MICROLIGHT AIRWORTHINESS APPROVAL NOTE

MAAN NO: 1681

TITLE: Microlight Airworthiness Approval Note 1681, ASI and altimeter corrections on Shadow Series B and BD aircraft.

BMAA Service Bulletin 1681

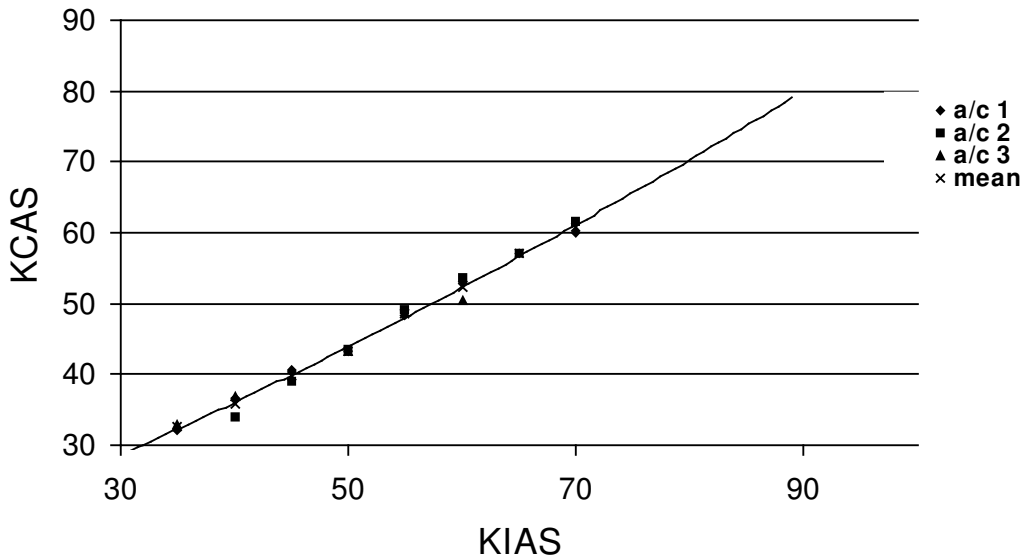
Three Shadow BD aircraft have been flown to establish the errors in the static system. In each case, the aircraft were flown using the ASI calibration method as set out in BMAA TIL027. This involves a 'racetrack' pattern being flown, recording ASI readings against GPS readings upwind and downwind.

The three sets of flight test data show good correlation, enabling a speed correction table to be produced with high confidence. This is shown in the attached Service Bulletin.
